## Product Change Notice (PCN)

**PCN Number:** PCN-0450260R-01

**Product(s) Affected:** MD-SM series (part numbers MD-30SM, MD-40SM, MD-50SM, MD-60SM, MD-70SM, MD-80SM, MD-90SM).

**New Design (MD-30SM, MD-40SM, MD-50SM, MD-60SM, MD-70SM, MD-80SM)**

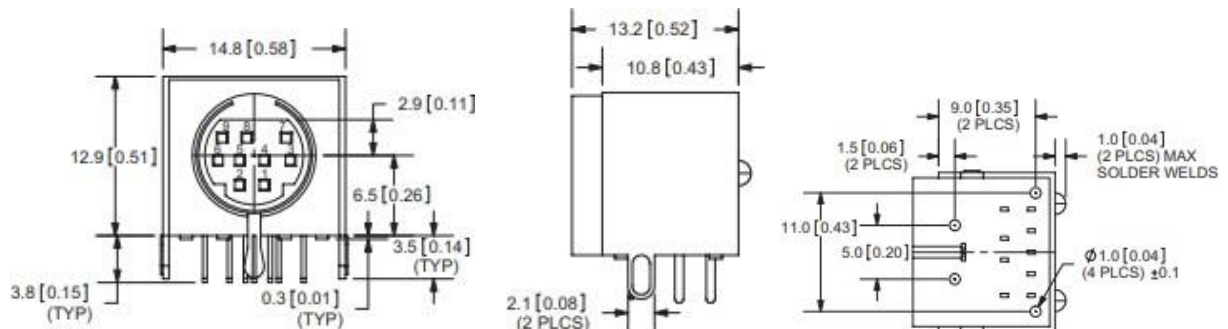
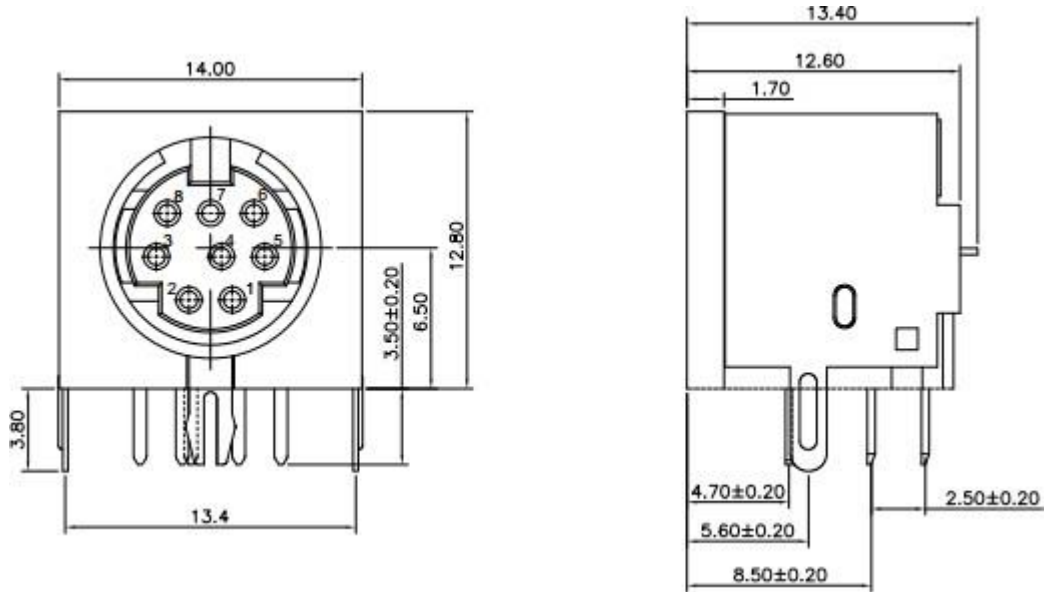
**Description of Change:** minor dimensional changes, and material changes, as shown below.

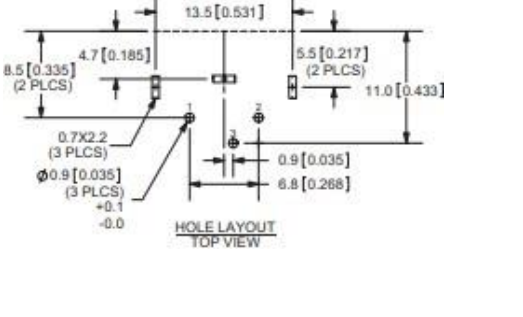
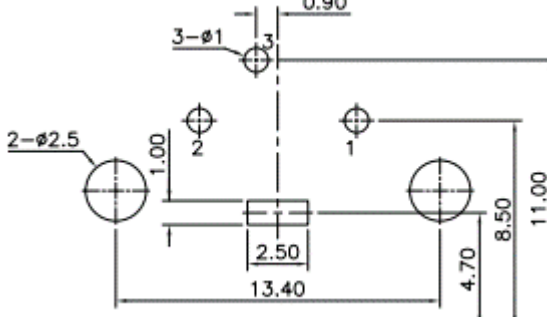
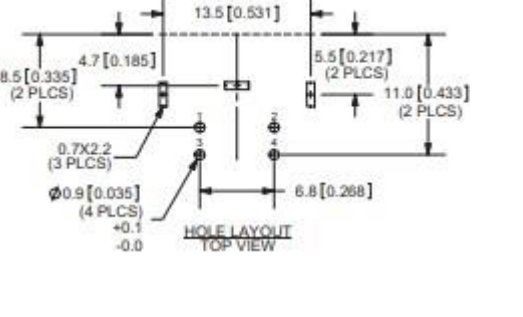
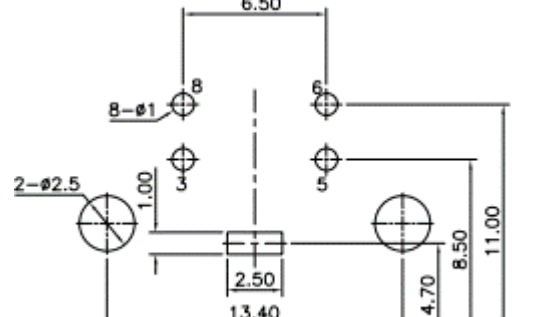
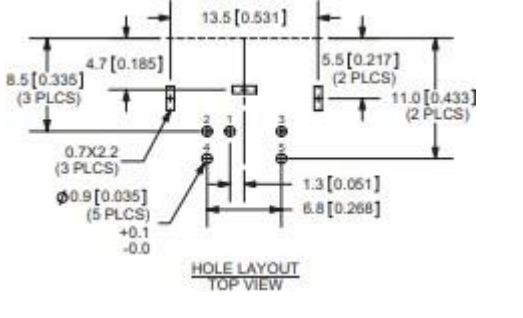
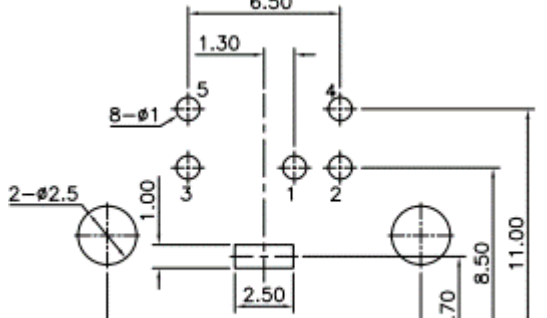
PCB Layout Old Design	PCB Layout New Design
 <p>HOLE LAYOUT TOP VIEW</p> <p>Dimensions: 13.5 [0.531], 8.5 [0.335] (2 PLCS), 4.7 [0.185], 5.5 [0.217] (2 PLCS), 11.0 [0.433], 0.7X2.2 (3 PLCS), <math>\phi 0.9</math> [0.035] (3 PLCS) +0.1 -0.0, 0.9 [0.035], 6.8 [0.268]</p>	 <p>Dimensions: 0.90, 3-<math>\phi 1</math>, 2-<math>\phi 2.5</math>, 1.00, 2, 1, 2.50, 13.40, 4.70, 8.50, 11.00</p>
 <p>HOLE LAYOUT TOP VIEW</p> <p>Dimensions: 13.5 [0.531], 8.5 [0.335] (2 PLCS), 4.7 [0.185], 5.5 [0.217] (2 PLCS), 11.0 [0.433] (2 PLCS), 0.7X2.2 (3 PLCS), <math>\phi 0.9</math> [0.035] (4 PLCS) +0.1 -0.0, 6.8 [0.268]</p>	 <p>Dimensions: 6.50, 8-<math>\phi 1</math>, 2-<math>\phi 2.5</math>, 1.00, 5, 5, 2.50, 13.40, 4.70, 8.50, 11.00</p>
 <p>HOLE LAYOUT TOP VIEW</p> <p>Dimensions: 13.5 [0.531], 8.5 [0.335] (3 PLCS), 4.7 [0.185], 5.5 [0.217] (2 PLCS), 11.0 [0.433] (2 PLCS), 0.7X2.2 (3 PLCS), <math>\phi 0.9</math> [0.035] (5 PLCS) +0.1 -0.0, 1.3 [0.051], 6.8 [0.268]</p>	 <p>Dimensions: 6.50, 1.30, 8-<math>\phi 1</math>, 2-<math>\phi 2.5</math>, 1.00, 5, 4, 3, 1, 2, 2.50, 13.40, 4.70, 8.50, 11.00</p>

<p>HOLE LAYOUT TOP VIEW</p> <p>Dimensions: 13.5 [0.531], 8.5 [0.335] (4 PLCS), 4.7 [0.185], 5.5 [0.217] (2 PLCS), 11.0 [0.433] (2 PLCS), 0.7X2.2 (3 PLCS), <math>\phi 0.9</math> [0.035] (6 PLCS) +0.1 -0.0, 2.6 [0.102], 6.8 [0.268]</p>	 <p>Dimensions: 6.50, 2.60, 8-<math>\phi 1</math>, 2-<math>\phi 2.5</math>, 1.00, 8, 6, 3, 2, 1, 5, 2.50, 13.40, 4.70, 8.50, 11.00</p>

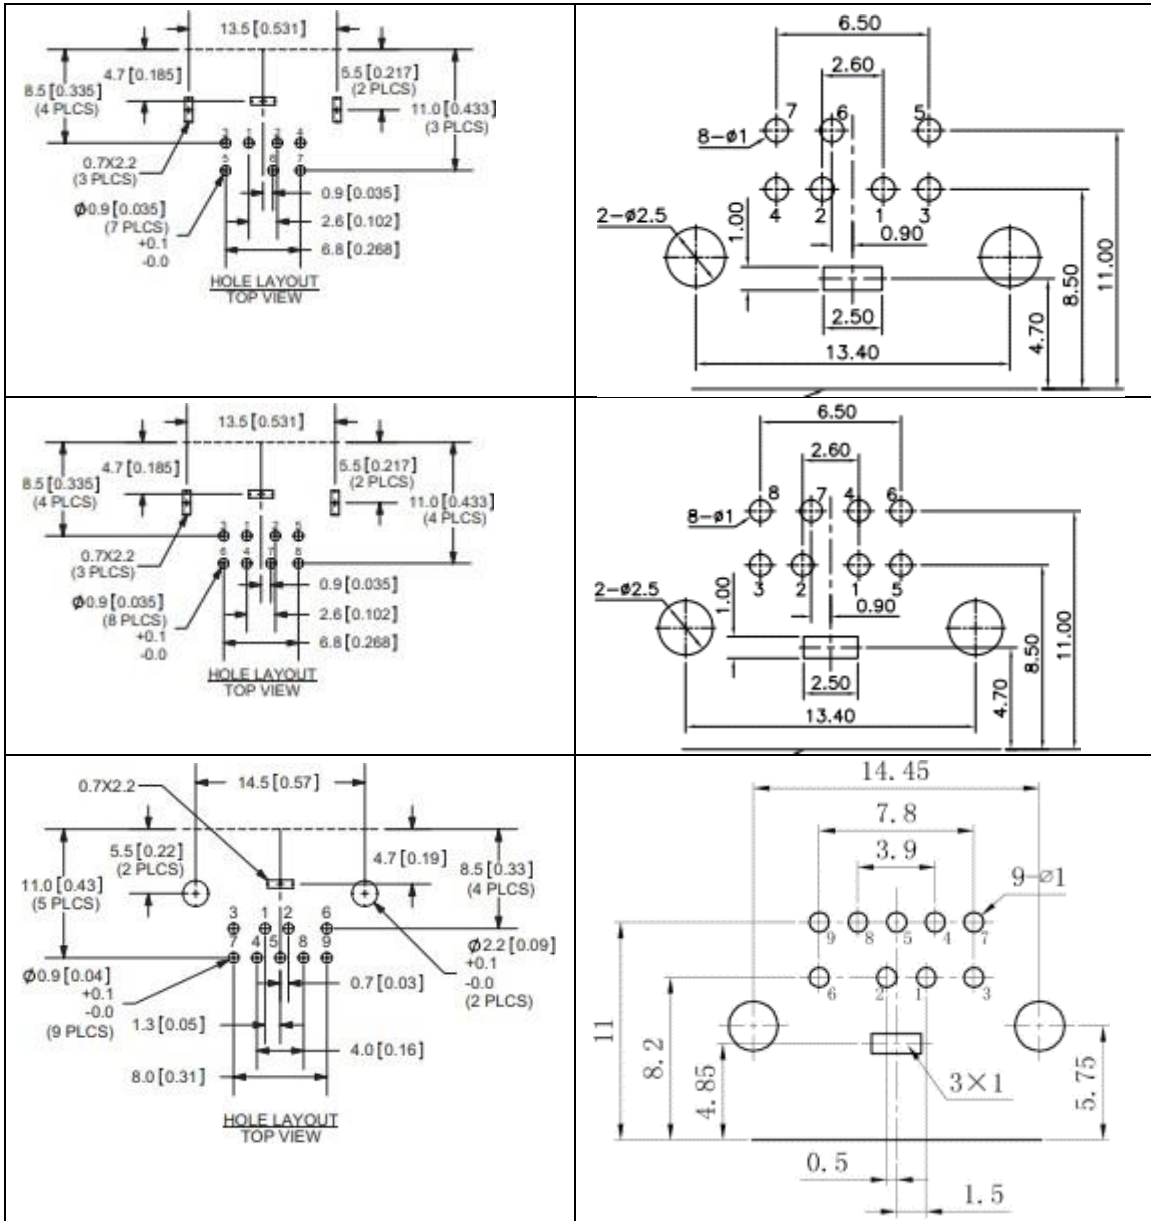
## Old design materials

MATERIAL	PLATING
earth terminal	brass	tin
contact terminals (1~9)	phosphor bronze	silver
shielding plate	steel	tin
housing	PBT

## **New design materials**

MATERIAL	PLATING
body	PBT+30%GF (UL94V-0)	
pins	brass	tin
shield	brass	nickel
